VILLAGE OF GERMANTOWN
N112 W17001 MEQUON ROAD
GERMANTOWN, WI 53022

MEETING:	PLAN COMMISSION
DATE AND TIME:	MONDAY, MARCH 26, 2018
	Immediately following General Government & Finance meeting but not before 6:30 p.m.
LOCATION:	Germantown Village Hall Board Room

CONDITIONAL USE PERMIT (CUP), SITE PLAN & SIGN PERMIT APPLICATIONS

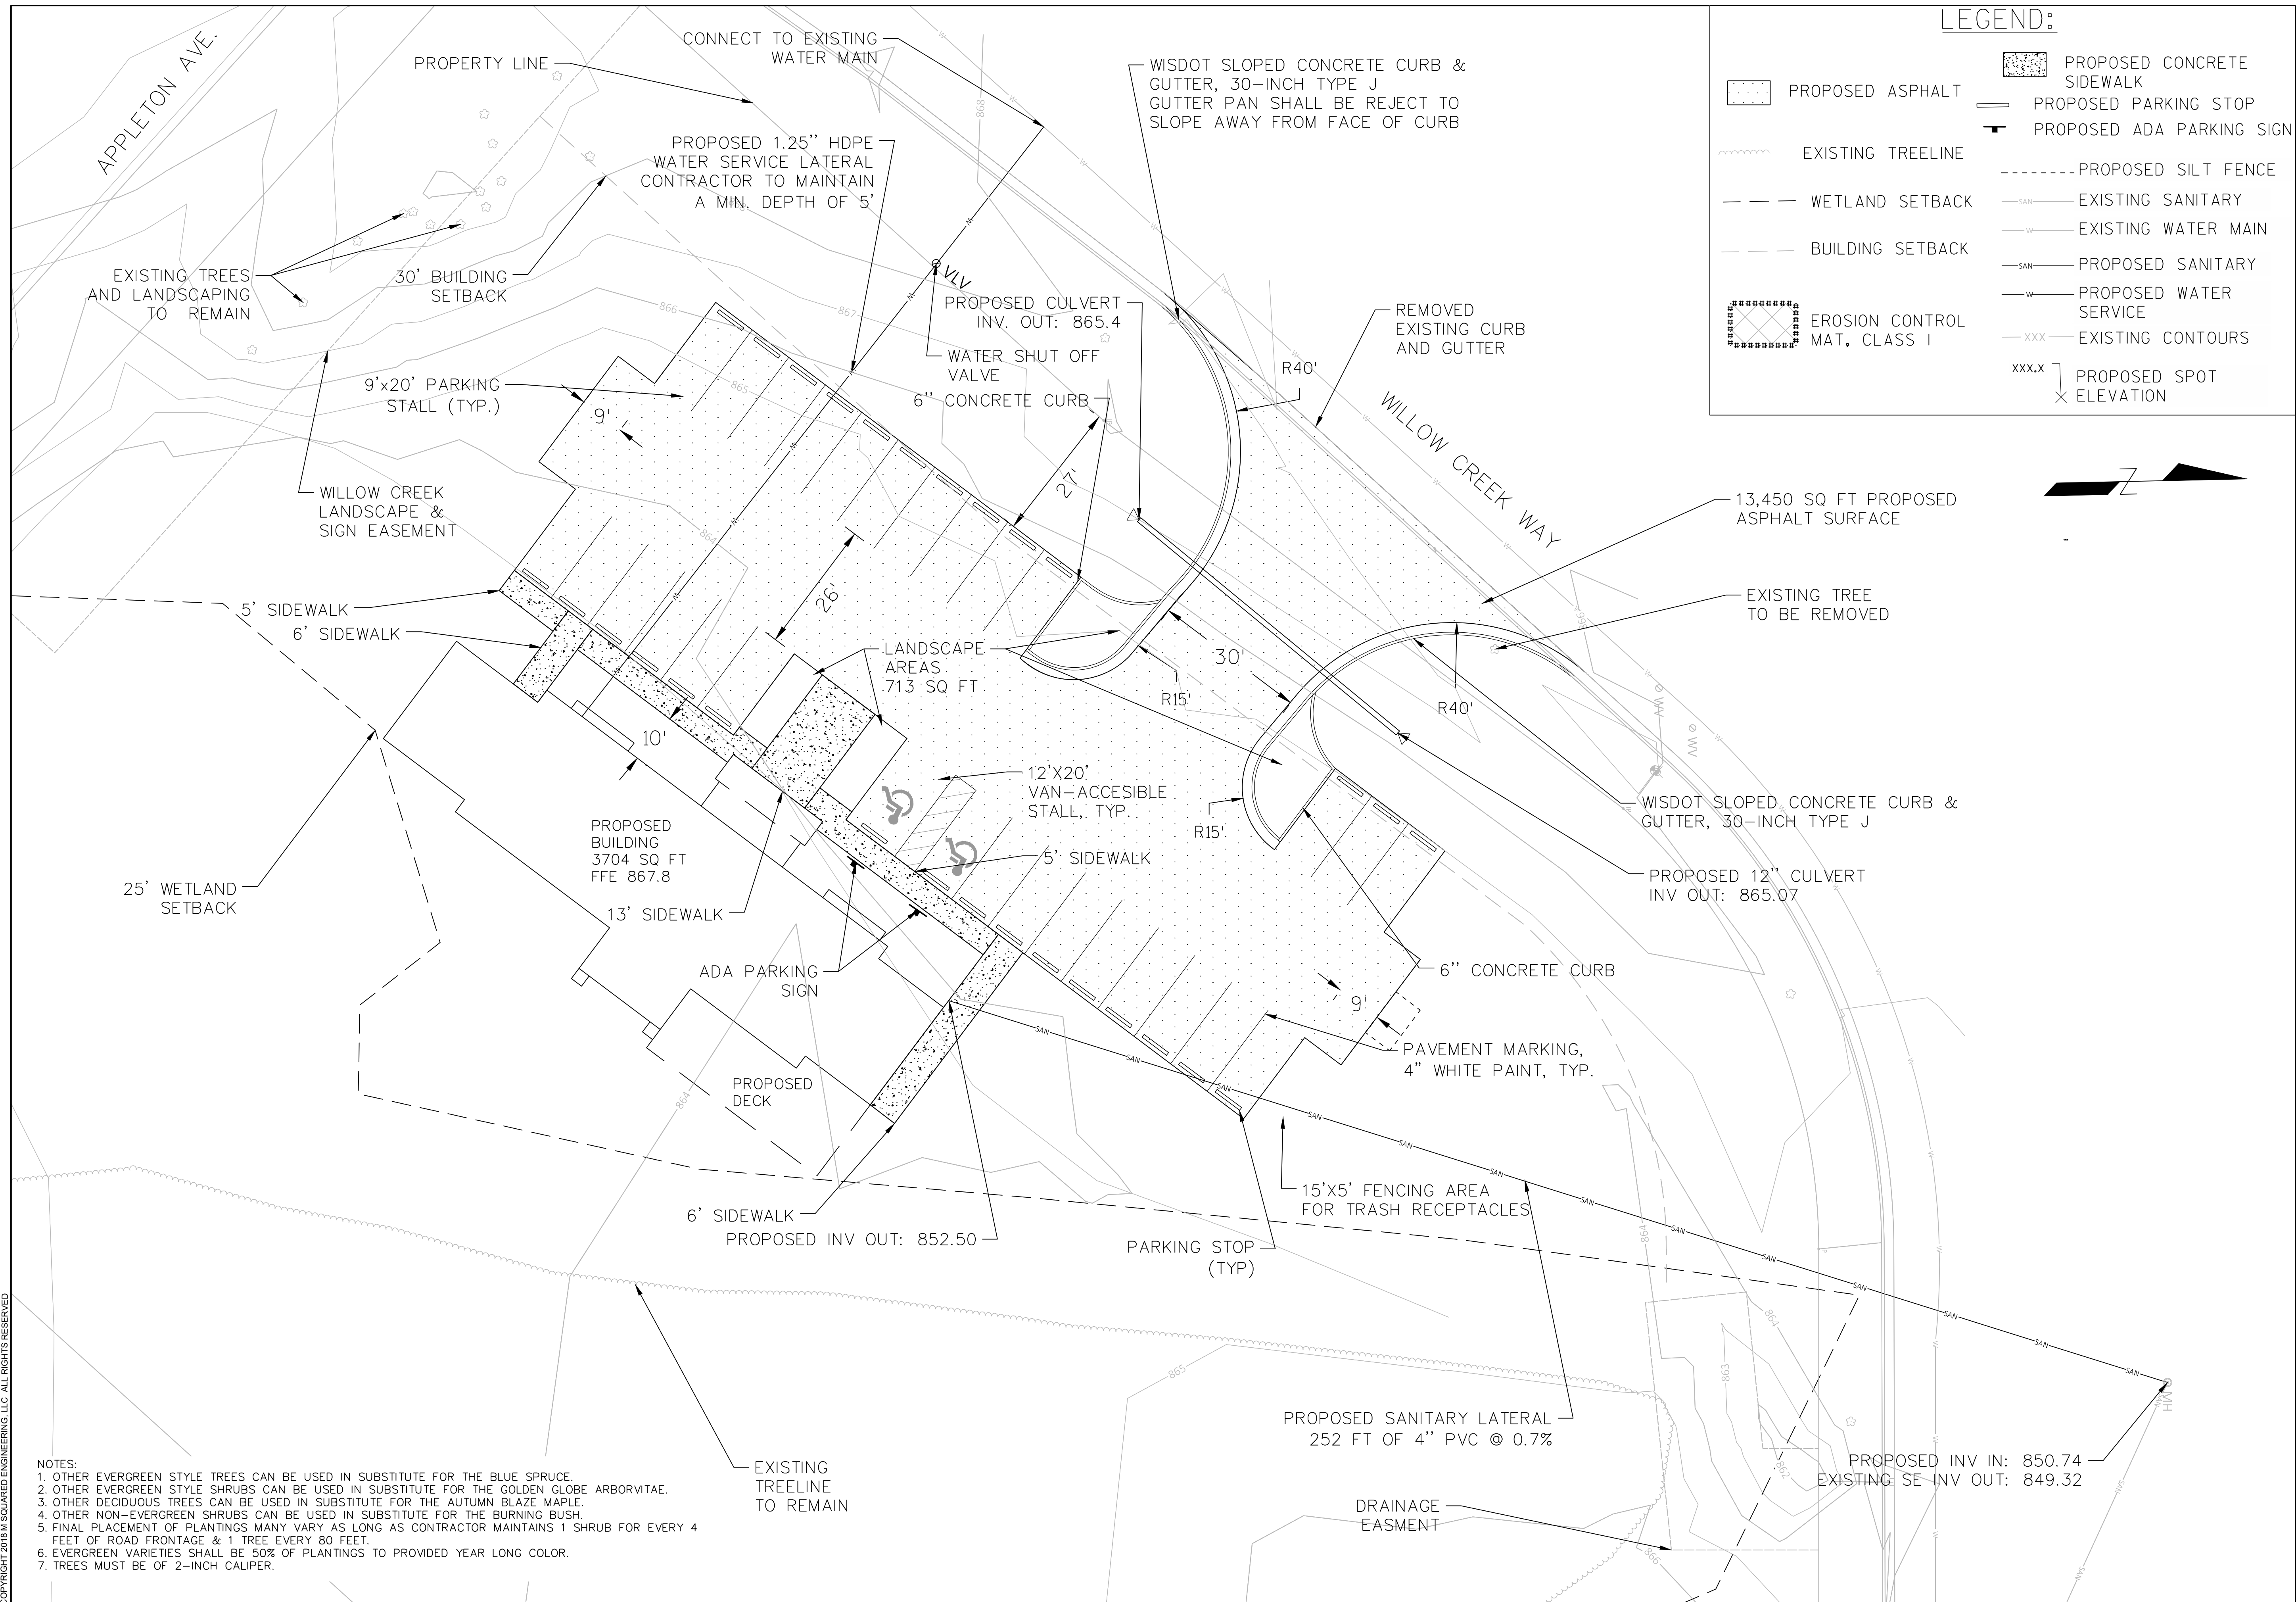
Sheet 4- Site Design

1. Please add a scale to this sheet.
2. Provide dimensions between the pavement/curb and the property line. Confirm required parking setbacks are met.
3. Show trash enclosure location and materials with the next submittal.

4. Show the existing wetlands location and date delineated.
5. Please provide justification for the entrance width and large radii, the entrance appears very wide for the passenger vehicle use. A smaller/narrower throat and smaller radii would likely lead to a less confusing entrance.

6. Show the turn lanes on Willow Creek Way as they relate to the proposed entrance, adjust drive accordingly.
7. Why is there curb in the greenspace to the north of the entrance islands?

8. Add pavement restoration areas and notes on the plans to restore the roadway to Municipal standards, including slurry backfill in roadway areas.
9. Revise the curb removal note at the drive to state replacing the curb with a depressed curb section to maintain the curblane flow thru that section.

10. Please darken the existing lot lines and add dimensions for parking and building setback as well as dimension from building to the lot line.
11. Label the size and material on the municipal watermain.

12. It is recommended the proposed sanitary sewer lateral have cleanouts installed on it over the distance. ALSO, revise the lateral size to 6" and the minimum slope to 1%.

13. Provide required vertical separation notes for sanitary service crossing over watermain.
14. A sampling/monitoring manhole along the sanitary lateral is required at or near the property line or R.O.W. Lateral connection to the main shall be approved by Village Engineering staff and cannot connect directly to a manhole but shall be located either upstream or downstream with a wye or Inserta-Tee depending on main diameter.

DRAWN BY:	DMD
DATE:	03/14/2018
CHECKED BY:	DCB
HORIZ. SCALE:	
VERT. SCALE:	
PROJECT NO.	18-193-003
REVISIONS	
DATE:	REVISED BY:
SHEET	
6

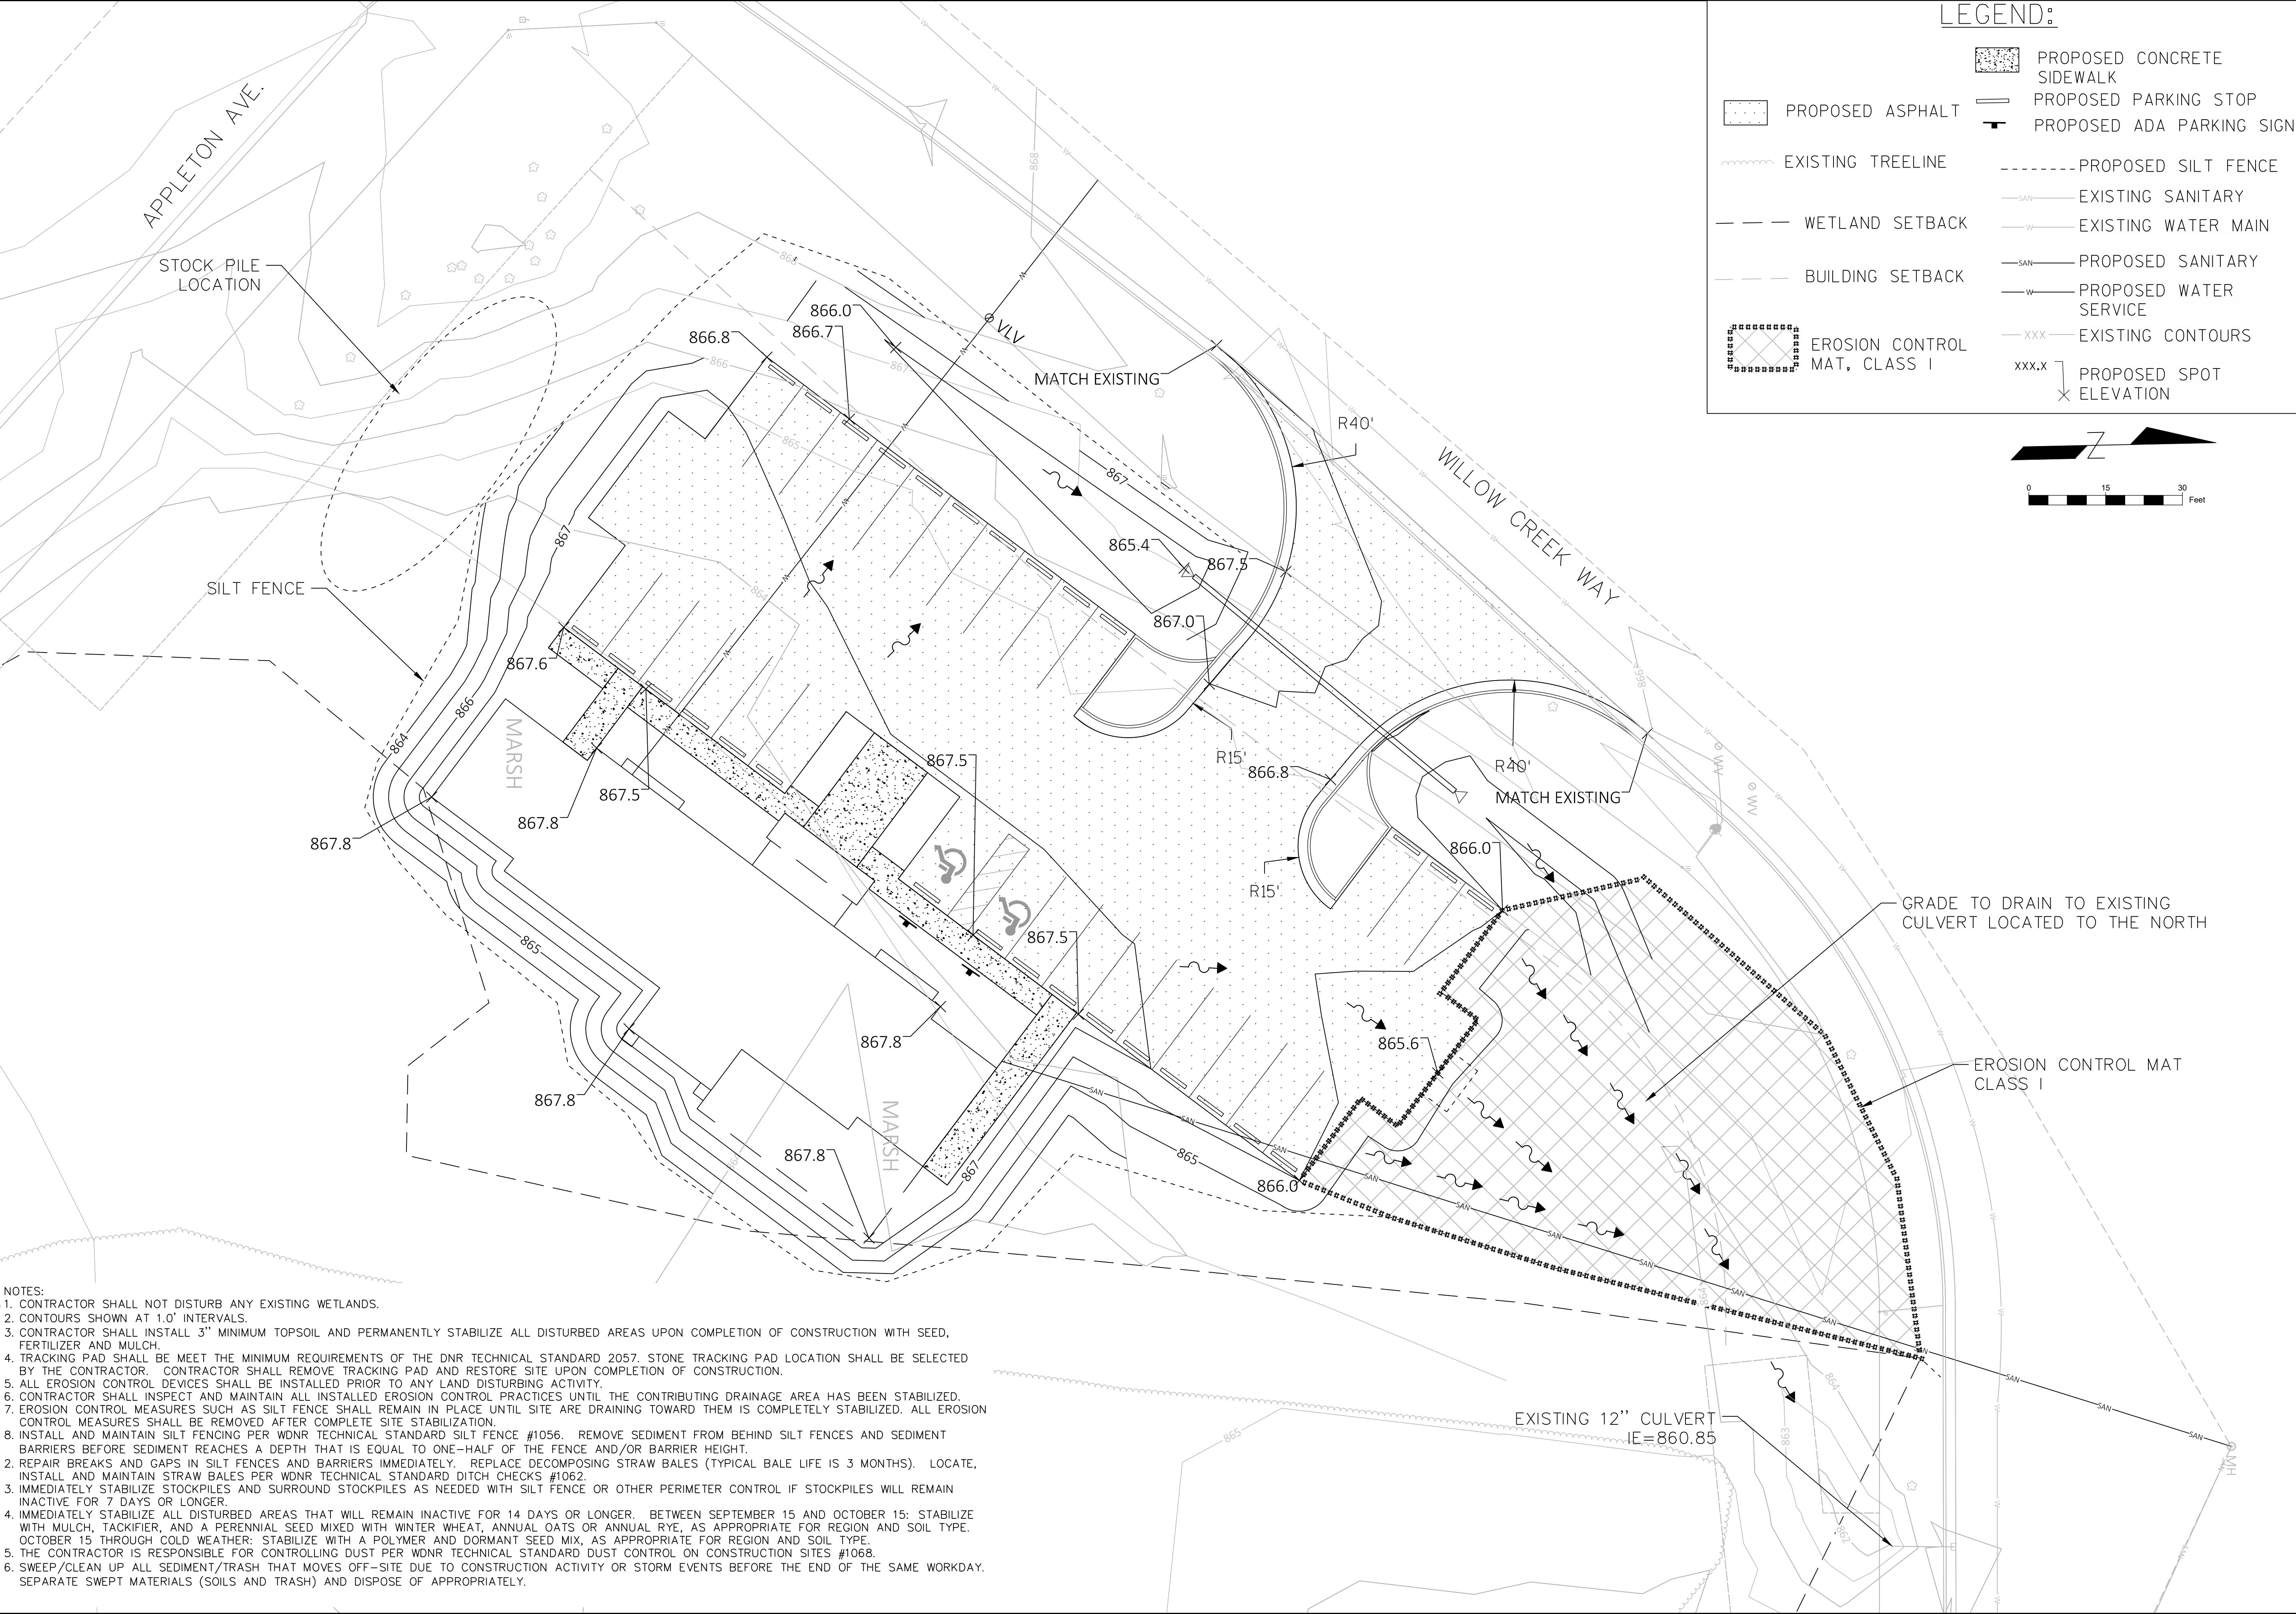
With regard to site development, the building is positioned in close proximity to the 25' wetland setback on the east side of the lot (see Grading & Erosion Control Sheet 6). In fact, 2-3 feet of fill is proposed in these areas that will encroach into the 25' setback... which is not allowed by right, but may be permitted with a conditional use permit and compensatory mitigation (development activities that involve over 3' of fill or impervious surface in a 25' wetland setback requires compensation at a 2:1 ratio). If the necessary fill and grading activities cannot be relocated beyond the 25' wetland setback, a separate conditional use permit to allow encroachment into the setback area will be required, along with the required compensatory mitigation plan that details how much area is encroached, how much area of compensation is required, where the compensation will take place and in what manner (e.g. enhanced wetland-friendly plantings to protect the wetlands elsewhere on the property).

Sheet 6 - Grading and Erosion Control Plan

1. Add dates and timeframes to the erosion control plan as well as total disturbance, overall site area and impervious areas added.
2. Provide and label slope ratio at the south and east slopes adjacent to the building.
3. Please add additional detail to the grading plan with the next submittal for the ADA parking areas as well as the center drive entrance area, there appears to be a potential flat spot in the lot currently.
4. Label the wetland setback on the grading plan.
5. It appears there are two areas of proposed grading that enter into the 25' wetland buffer setback, please address these areas and the grading per the Village's buffer requirements.
